Meeting Agenda

Plat Committee

Monday, January 9, 2023	5:30 PM	ZOOM ONLY MEETING - Meeting Not Physically Open
		To Public

1.	KPB-4838Bay Ridge Estates Lot 22 Caron 2023 Replat; KPB File 2022-175Seabright Surveying / Caron	
		Location: Diamond Ridge Road
		Diamond Ridge Area
	<u>Attachments:</u>	E1. Bay Ridge Estates Lot 22 Caron 2023 Replat_Packet
2.	<u>KPB-4839</u>	Brown's Acre Estates Addition No. 1; KPB File 2022-170 Peninsula Surveying, LLC
		Anchorage Development & Construction, LLC
		Location: Lopez Avenue
		Sterling Area
	<u>Attachments:</u>	E2. Brown's Acre Estates Addn. No. 1 Packet
3.	<u>KPB-4840</u>	Fort Raymond Subdivision No. 1 Hemlock Addition; KPB File 2022-177
		R&M Consultants, Inc / City of Seward
		Location: Hemlock Avenue, Sea Lion Avenue & Seward Highway
		City of Seward
	<u>Attachments:</u>	E3. Fort Raymond Sub No. 1 Hemlock AddnPacket

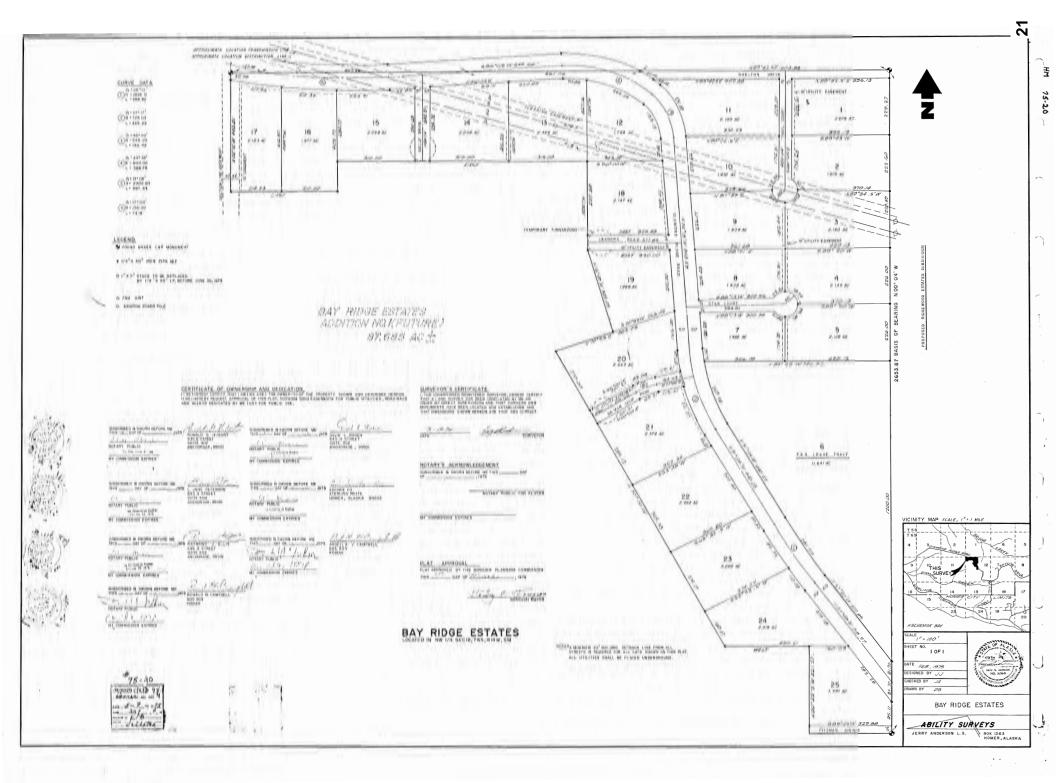
The parent plat did have a note that "all utilities shall be placed underground." There are currently overhead powerlines within the right-of-way dedication. The plat indicates the intention to carry over the plat note from the parent plat. The installation of utilities will be between the land owners and the utility providers as the borough does not provide any utilities and does not have the ability to enforce such a restriction. **Staff recommends** the plat note be removed or update the note "All utilities shall be placed underground per HM 75-20. Consult with utility providers regarding this plat note."

An easement was granted to Homer Electric Association for a non-disclosed location within the NW1/4 of the section. That easement was later released by Homer Electric Association for the one within Lot 22. **Staff recommends** add plat note, "An easement was granted to Homer Electric Association was granted with no location disclosed in Book 49 Page 262, HRD. That easement was released by Homer Electric Association for Lot 22 as found in Book 182 Page 241, HRD."

Show recommended 15' HEA easement line and add label or plat note.

HEA	Provide a label or plat note stating, "The existing underground powerline within Lot 22-B is the centerline of a 15-foot-wide electrical easement, including pedestals, granted this plat"
ENSTAR	No comment of recommendations
ACS	
GCI

- On the drawing at the top correct the township accordingly.
- Call out the corner as the ¼ corner.
- In plat note 4, add <u>per</u> in front of the plat reference.

Staff recommendation: Remove "Subdivision" from parent legal description. Update the township.

Staff recommendation: Provide a depiction and label for the lot across Diamond Ridge Road.

KPB 2022-177 12/14/2022

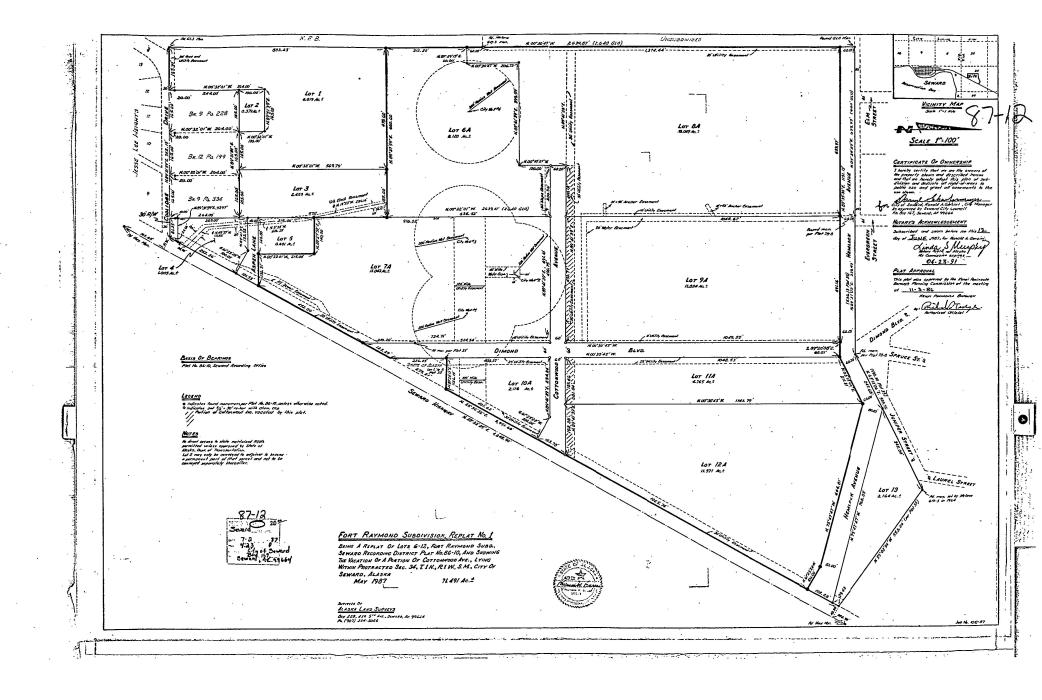
Provide a legend on the final plat.

- This plat was submitted as Hemlock Subdivision. The parent plat's name shall be the primary. Staff is currently calling this Fort Raymond Subdivision No. 1 Hemlock Addition. If the owners wish to provide a different name they may as long as the parent plat name is the primary. Please contact staff for name approval prior to submitting the final.
- The current title block states Tract A and B which this plat is creating but they are in the same font style and immediately after the title name. This could be interpreted as part of the subdivision name. Staff suggests if that information is wanted it be placed in a different font and states "Creating Tracts A and B".
- Update the location to E1/2
- Include "City of Seward" within the location information.
- Update the recording district to "Seward"

Staff recommendation: The boundary for the City of Seward and Chugach National Forest should be added with labels.

- The subdivision name for Q-2 to the west is incomplete.
- Lot 7A located to the southwest was replatted by SW 2022-12 and should be updated.
- Adjust the subdivision label and plat number to the south as it only applies to Lot 10A
- Zoning labels should be removed
- Add a "widths varies" within the Highway dedication along with the DOT project information that information was taken.
- Add an additional Hemlock Avenue label for the depiction west of Dimond Boulevard.
- L. Contours at suitable intervals when any roads are to be dedicated unless the planning director or commission finds evidence that road grades will not exceed 6 percent on arterial streets, and 1 0 percent on other streets;

Staff recommendation: Remove drainage structures shown on drawing.

Staff recommendation: comply with 20.60.110. add measured and recorded distances on final with reference plat.

Staff recommendation: If using a Notary's Acknowledgement is must comply as it is currently a combination of acknowledgment and jurat. May be changed to Jurat if desired. As the City of Seward is the only owner of the property, remove "Owner, Tracts A & B, Hemlock Subdivision". If it is desired to list the property it should be of the parent lot as Tracts A & B do not exist until recorded. Comply with 20.60.190.

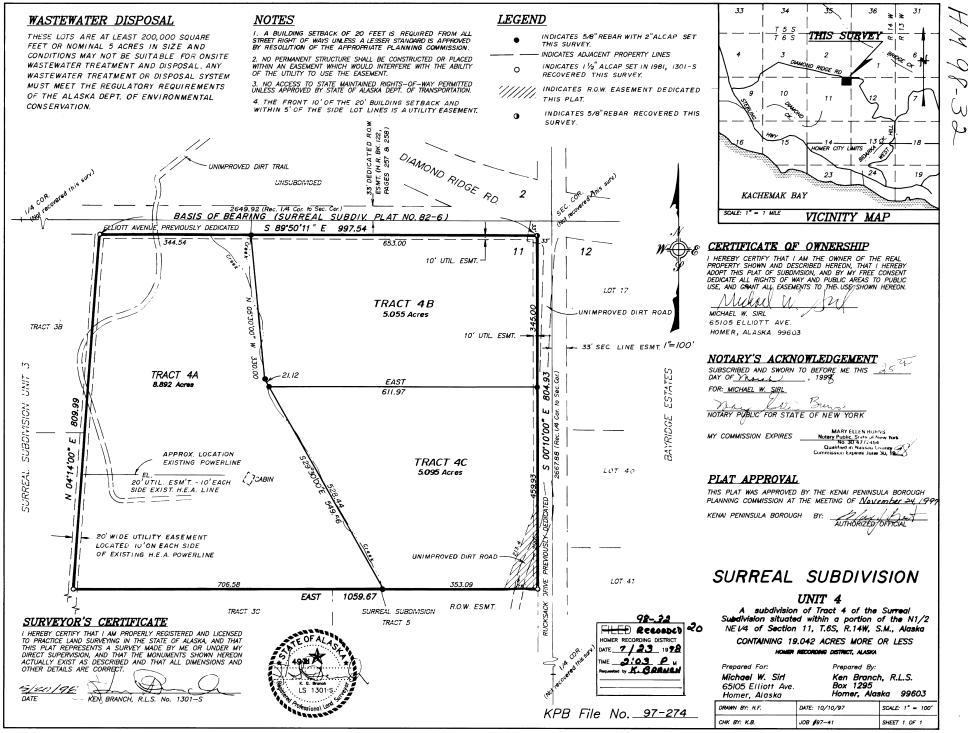
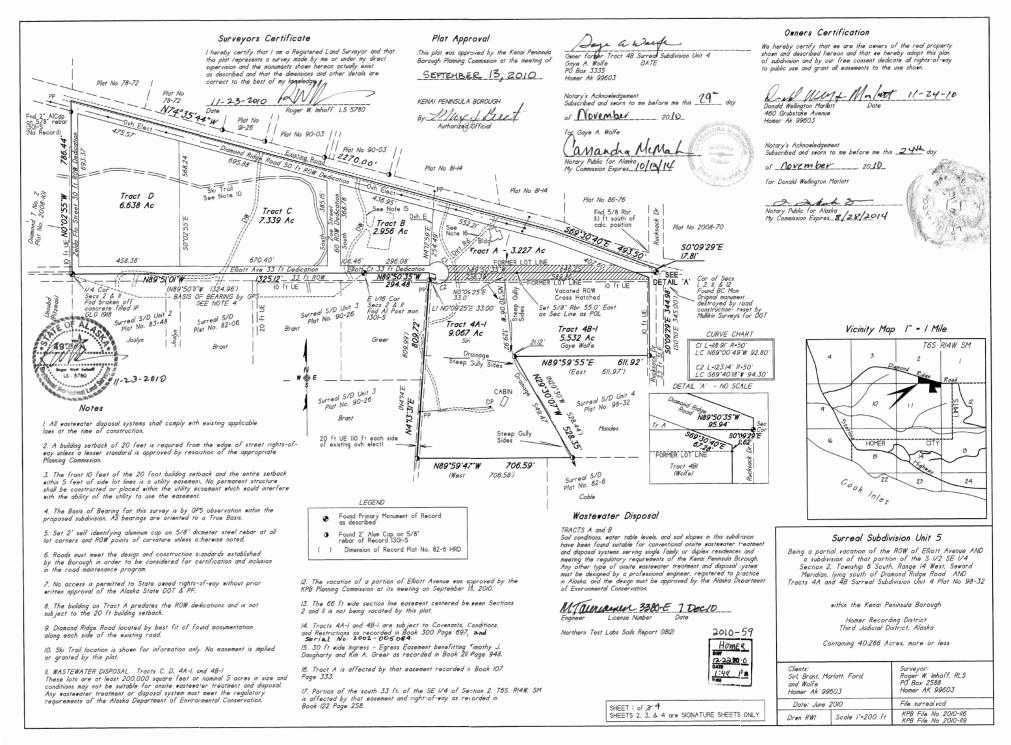
Proposed Tract C-1 will have access from Diamond Ridge Road and has the existing private access road within its boundary. Elliott Avenue will also be able to provide access. Tract C-2 will have access from Diamond Ridge Road and Zoe Street. Tract C-3 will have access from Elliott Avenue and Tract C-4 will also have access from Elliott Avenue and Zoe Street. Permitting and approval for access to Diamond Ridge Road will be done by Alaska DOT. *Staff recommends* a plat note be added that states approval for access is through Alaska DOT.

Zoe Street and Elliott Avenue are not currently constructed. If the owners wish to allow owners of the new lots to use the existing private access road, *staff recommends* additional access easements be recorded when the ownership of the lots change.

As discussed above, there is an existing private access road within the subdivision that is subject to a recorded private easement. There does not appear to be any encroachment issues being created by this plat. There is a structure close to the property line in the southwest corner. This plat would not be creating an encroachment issue and would be a civil matter if it is encroaching. **Staff recommends** the surveyor verify the location of the structure during the field survey and notify staff the status of the structure and if it is an issue and a statement for resolution.

The plat does show a seasonal ski trail. This trail was depicted on the parent plat and the plat note is proposed to be carried over that states it is for information only and no easement is implied or granted. Unless an access easement is granted Tract C-4 will have to cross the existing ski trail for access. A comment was received by a land owner to the west. They are requesting the landowner grant a permanent easement for the trail. Staff was not able to find within KPB Code that this could be something we can require for this plat. If there is documentation to demonstrate an established public right to the trail we could address some options. At this time the granting of an easement atop the existing ski trail is at the discretion of the land owners. Based on the inclusion of Plat Note 7 there does not appear to be an interest in granting an easement.

HEA	Revise to 15 foot wide easement within Tract C-1 and within plat note 8
ENSTAR	No comments or recommendations
ACS	
GCI

Staff recommendation: For Lots 1A, 1C, and 1B to the south, adjust the plat number so it is clear it is for all three lots. Update the label Lot 4A located to the north and east of Lot 4D. East of Zoe Street, add a label for Elliott Court.

- "No access to state maintained rights-of-way permitted unless approved by the State of Alaska Department of Transportation."
- The certificate to plat indicated some additional easements were granted by recorded document. Add a plat note, "Subject to private easements recorded in Book 107 Page 333 and Book 122 Page 258, Homer Recording District." Depict the easements as described and if it is found that those easements are no longer within this subdivision work with the title company for removal or if the

easements are now within a dedicated right-of-way they do not require depiction but add to the note "Easements are located within the STREET NAME right-of-way dedication."
